Title		F1 MAIN	
Size	A2	Document Number	SMBT350LW POWER
Date	Tuesday, June 14, 2022		Sheet

File	F1 MAIN
Size	Document Number
A3	SM81380AWL POWER
Date	Thursday, May 26, 2022
Sheet	3
6

HAPTICS

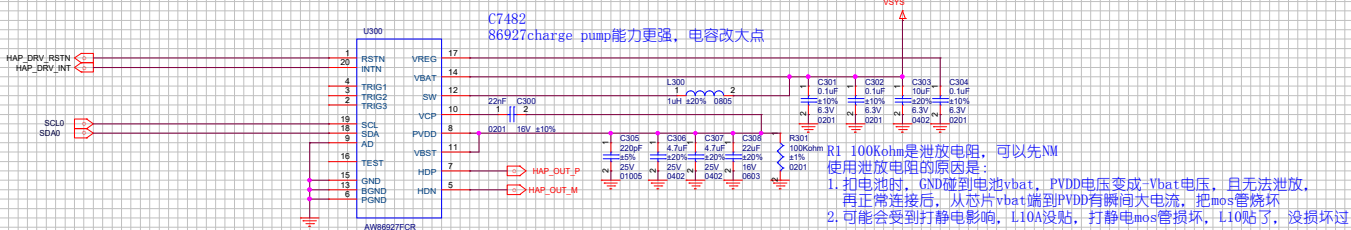
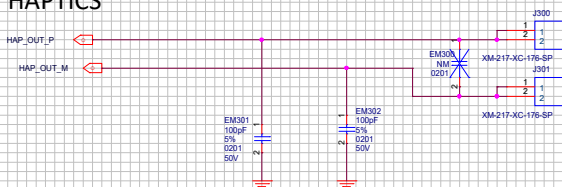
【注意】HAPTICS未来在小板上
L0201 限高1.0以上，使用240100000N79
限高0.8，则使用24V01R0P11E6

HAP_DRV_INT、HAP_DRV_RSTN还未接

Slave2 BAT CON

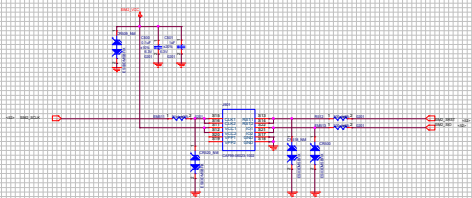
Global and India
Type-C Part Number
are different from CN
